# Access Compliance Report

## Public Rights-of-Way

| Intersection ID: 24840                  | Main Street: REA_RD | Cross Street: MACANDREW_DR              | Location: SE           |
| ADA ID: B198EEF643FF                    | Ramp Type: Perp     | Initial Pass/Fail: Fail                 | Overall Compliance: No |

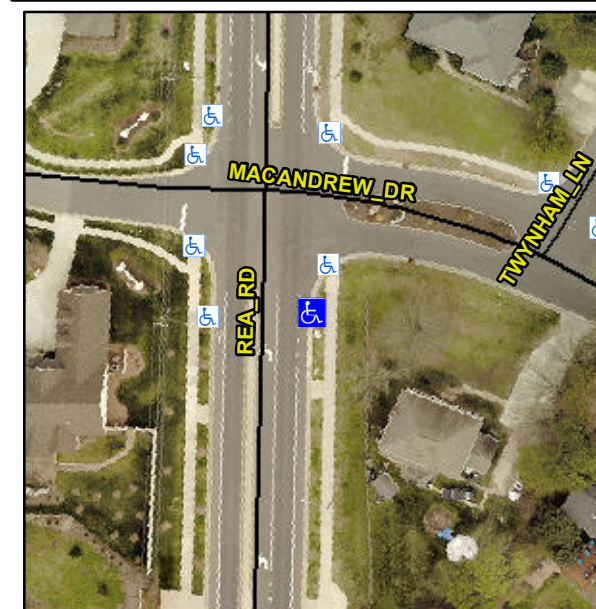
**Not Found, R304.2.2, R304.5.3**

| Compliance | Description           | Data | Compliance | Description                 | Data |
|------------|-----------------------|------|------------|-----------------------------|------|
| N/A        | Ramp Length (in)      | 96.5 | No         | Ramp Slope (%)              | 8.8  |
| Yes        | Ramp Width (in)       | 69.0 | No         | Ramp XSlope (%)             | 2.2  |

**Remove & Replace Entire Ramp.**
